## Index 102-665 Limited Access, Temporary Opening

Sheet 1: Revised Details and Notes 1-3, 9 & 12; Updated Symbols; Deleted Notes 4 & 6;  
Moved Notes 5, 7, 8, & 13 to Spec 102.

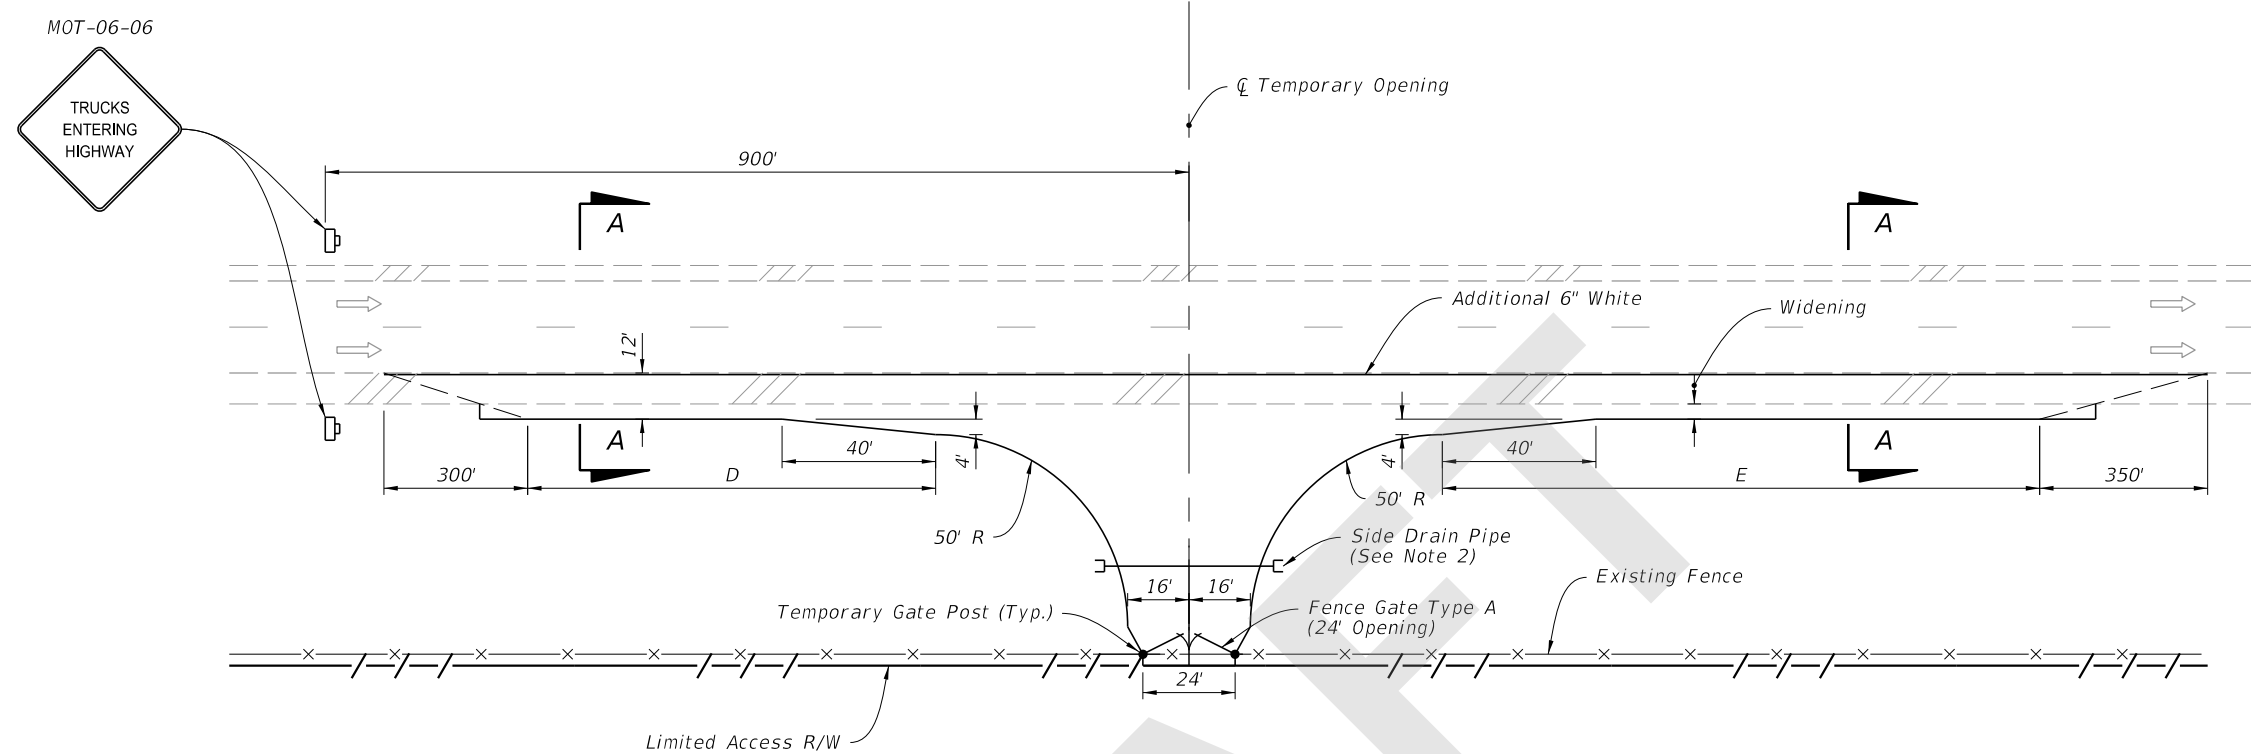
Should Note 4 be placed within Spec 102? It establishes criteria for placement in general.

**RESPONSE:** Agreed, the notes have been revised.
